AGENDA
ST. TAMMANY PARISH ZONING COMMISSION MEETING
6:00 P.M. – TUESDAY, MARCH 7, 2023
ST. TAMMANY PARISH ADMINISTRATIVE COMPLEX, COUNCIL CHAMBERS
KOOP DRIVE OFF OF HIGHWAY 59
MANDEVILLE, LOUISIANA

Proposed Use: Monarch Wellness Urgent Care: Change of Use **Gross Area Lot Size:** 1.267 acres
Previous/Current Use: Office **Use Size:** 2,400 sq. ft.
Owner: Chris Combs Properties, LLC **Council District:** 1
Applicant: Chris Combs **Posted:** February 17, 2023
Commission Hearing: March 7, 2023 **Prior Determination:** Denied - December 6, 2022

Scale: 1" = 20'

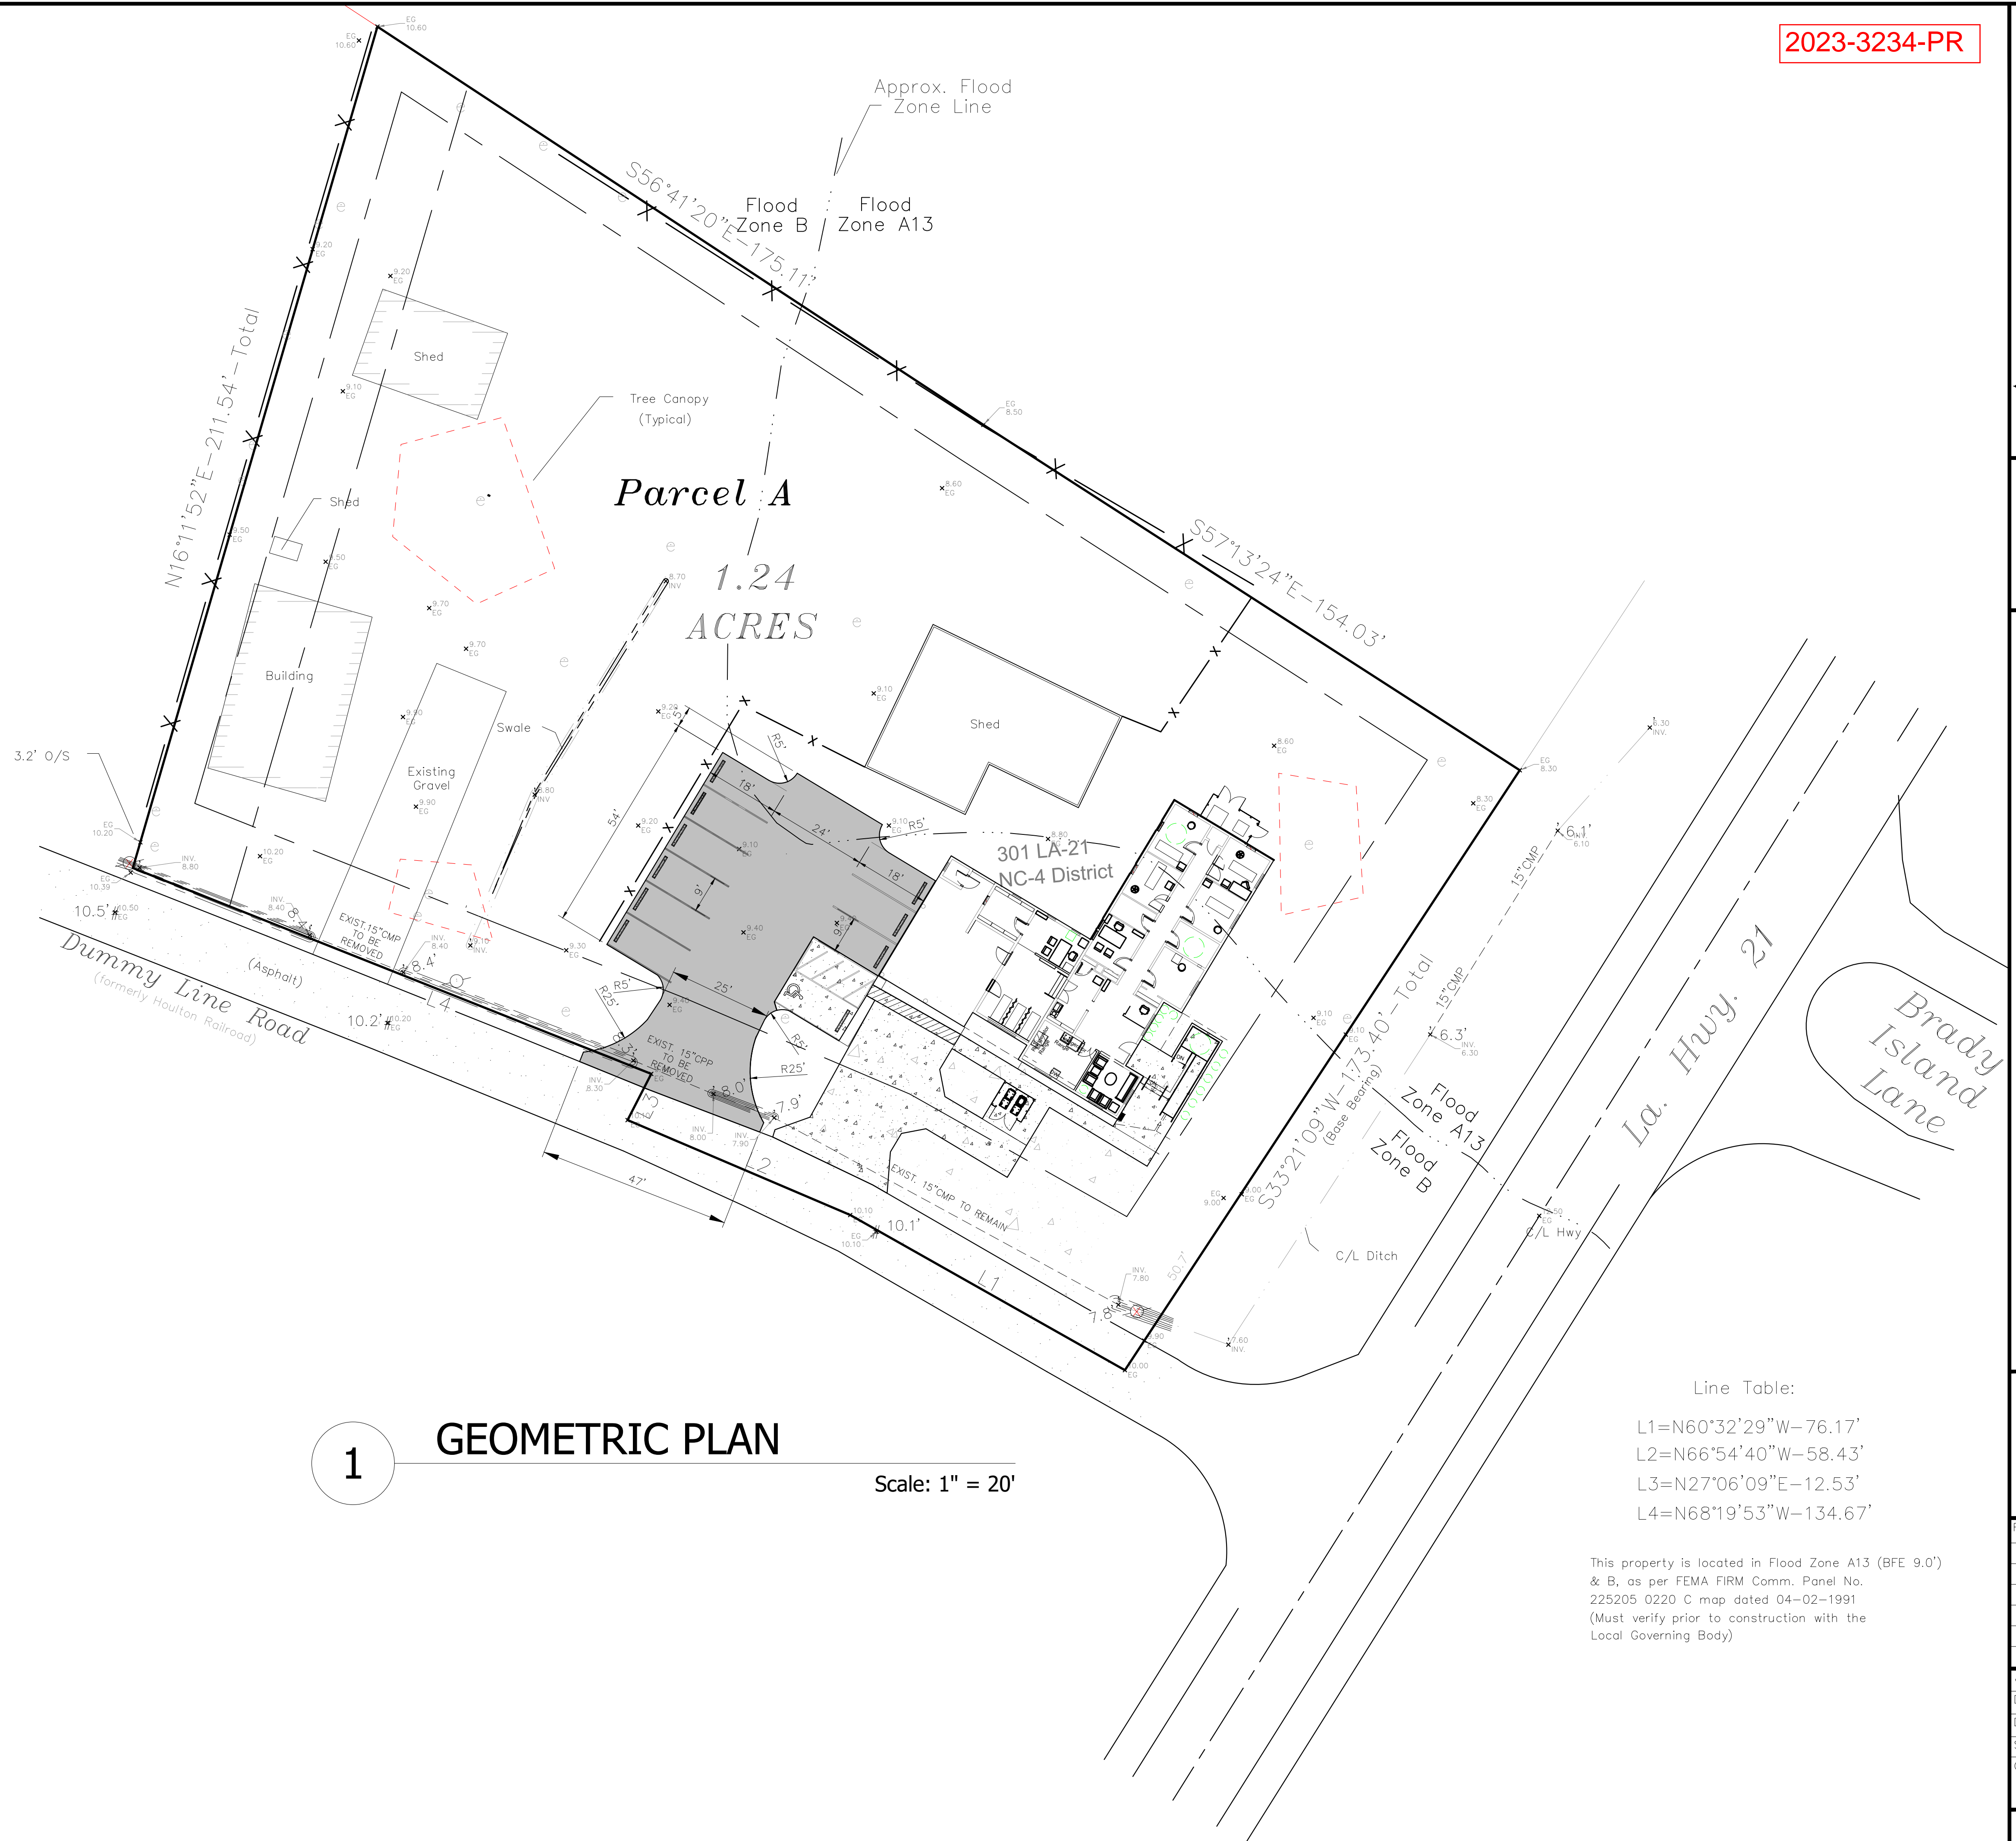
- **The proposed landscape plans show an existing 8" oak, an existing 18" live oak, and an existing 30" live oak within the Highway 21 street buffer. This provides the applicant a total of 10 tree credits, therefore reducing the total plantings required to 13 Class A trees and 35 Class B trees.**

- **The landscape plan provided is proposing to plant 2 additional Class A trees and 4 additional Class B trees. Therefore, the applicant is requesting a waiver to the required number of trees within the Highway 21 Street Planting buffer for the following: 11 Class A trees and 31 Class B trees.**

- **Staff recognizes a portion of the existing building and an existing concrete pathway from the parking lot to the front door of the establishment impedes upon the required 40' street buffer, therefore eliminating plantable area. Staff also recognizes the existing large oak trees within the street buffer also impede the plantable area. The landscape plan submitted shows an abundance of trees proposed within the buildable area of the site that are not required, therefore mitigating the reduction of required Class A and Class B trees in the Highway 21 street buffer.**

- **Existing conditions on the site provide 5 parking spaces which are located along the southern side of the building façade and currently back into the Dummyline right-of-way. While the previous site and landscape plan for the property (Case No. 2022-3128-PR) was proposing to maintain this existing parking configuration, the applicant has submitted new documents for review which are proposing the removal of the five existing parking spaces along Dummyline in order to provide the required 20 ft. street planting buffer and a more appropriate on-site circulation pattern.**

- **The current configuration of the property shows an existing 20' gravel driveway servicing the residential dwelling to the west of the site, an existing 24' concrete driveway servicing two parking spaces under an existing carport towards the eastern end of the site, and a proposed 24' concrete driveway to service the new proposed parking lot. This proposal exceeds the number of driveways which are permitted through a street planting buffer and will therefore incur a waiver request to the number of two-way-driveways allowable on a site. Staff recommends the applicant**

revise the plans to show the current driveway to the east of the site and the proposed parking lot driveway be connected and therefore reduced to 1-way driveway widths.

5. Per Sec. 130-1976, a street planting area is required to provide 1 Class A tree, 1 Class B tree, and 1 shrub per 30 linear feet of street buffer.
 - **The Dummyline Road right of way requires 9 Class A trees, 9 Class B trees, and 27 shrubs. The proposed landscape plan shows an existing 8" Live Oak, an existing 24" Pine, and two existing 6" Black Gums for a total of 9 tree credits. The landscape plan proposes to plant 6 additional Class A Live Oak trees and 3 additional Class B Iron Wood trees, therefore meeting the requirements of the street planting area.**

6. Per Sec. 130-1814(1)(e)(1)(ii), a non-residential property abutting a residential district shall have a minimum side yard and rear yard requirement of 30 feet.
 - **The western boundary of the property abuts a residential district, therefore requiring a 30 ft. rear yard buffer. This portion of the property is currently developed with an existing house and shed which encroaches upon the 30 ft. buffer. Although this area is outside of the scope of work as indicated by the "limit of work" line, the applicant is proposing to exceed the required number of trees by planting 6 new Ironwoods, therefore increasing the buffer between the adjacent residential zoning district and the existing commercial site.**

7. Per Sec. 130-1977, the landscape plan must provide a 10 ft. side yard buffer with 11 Class A trees and 11 Class B trees.
 - **The landscape plan submitted shows a 10 ft. side yard buffer with 11 tree credits and 11 additional Class B trees, therefore meeting the ordinance.**
